Ashbourne House, Crich

**Design Statement: ADDENDUM**

Proposed New Dwelling: Ref AVA/2021/1200

March 2022

Image: Sketch of ground floor on the site plan used to inform discussions with planning case officer.

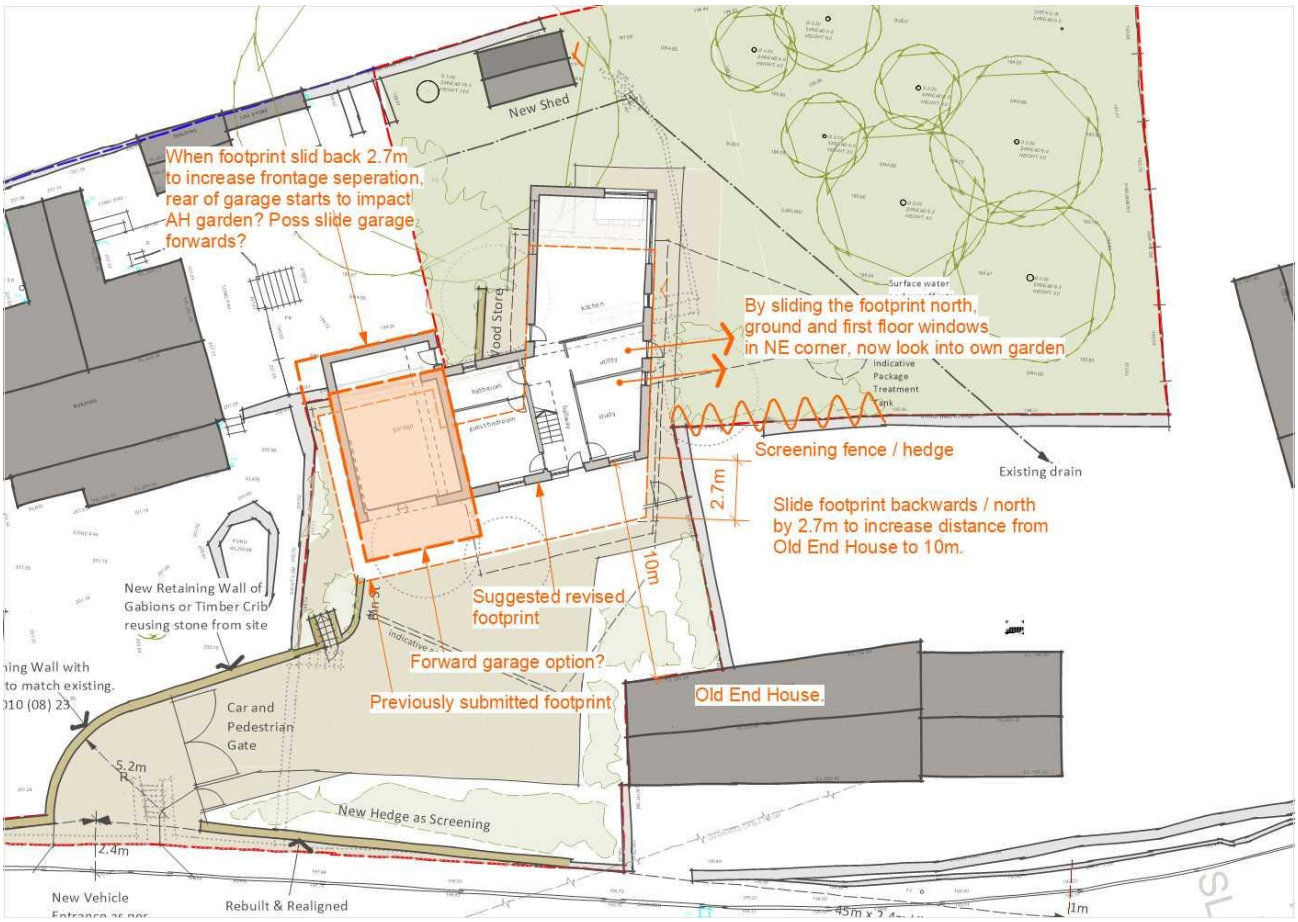
The possibility of increasing the separation distance between Old End House (OEH), that is to the south east of the site, and of the proposed new dwelling has been discussed with the case officer and applicant at length.

On the original submission, the distance from OEH to the new dwelling was 7.3m. This position was determined by the desire to avoid the rear of the new property being within the Root Protection Zone (RPZ). However, as can be seen on the below sketches, if the house is slid to the north (along the line of the angled east elevation, not directly backwards from the front elevation) by circa 2.7m, then the separating distance between OEH and the new dwelling can be increased to 10m.

However, as can be seen from the sketch, the rear of the garage which projects beyond the rear elevation to give a rear access door and canopy for access to the kitchen, would now be outside of the red line originally forming the application. Therefore, proposals are to pull the garage forwards, so the rear elevation of it aligns with the rear of the house. Without the rear access to the garage, the footprint of the house will also be moved to the west by circa 200mm to slightly increase the width of the access to the side or east of the house.
